## **Proposal for a Supplement to the 02 Series of Amendments to UN Regulation No. 90**

Note: This proposal aims at addressing the issue concerning the approval number with Schedule 4 of Revision 3 of the 1958 Agreement

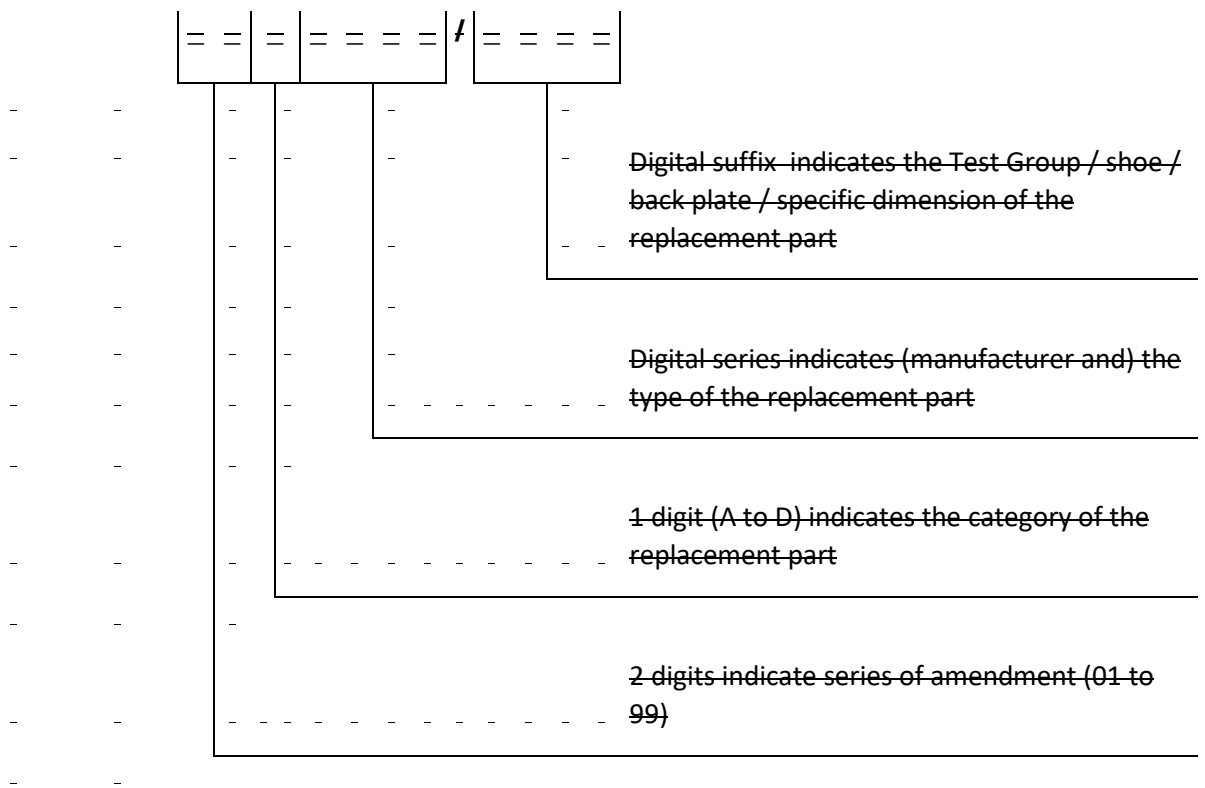
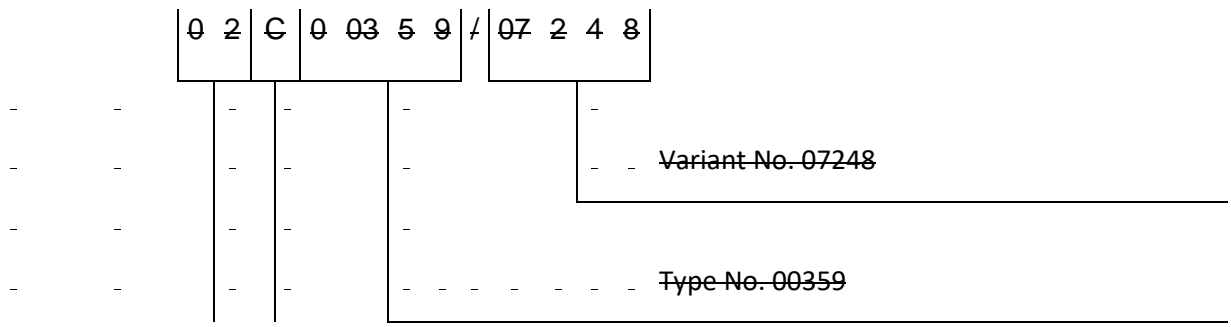
Paragraph 4.2 amend to read

4.2. To each replacement part approved there shall be assigned an approval number **according to Schedule 4 to the Revision 3 of the 1958 Agreement wherein Section 3 of the Type Approval Number shall indicate the Test Group for** ~~comprising four groups of digits:~~

- A Replacement brake lining assembly**
- B Replacement drum brake lining**
- C Replacement brake disc**
- D Replacement brake drum**

**The variants approved as a Test Group shall be listed as an appendix to the communication document**

~~4.2.1. The first two digits (at present 02 for the Regulation in its 02 series of amendments) shall indicate the series of amendments incorporating the most recent major technical amendments made to the Regulation at the time of issue of the approval.~~

~~4.2.2. The following single digit shall indicate the category of the replacement part as follows:~~

- ~~A Replacement brake lining assembly~~
- ~~B Replacement drum brake lining~~
- ~~C Replacement brake disc~~
- ~~D Replacement brake drum~~
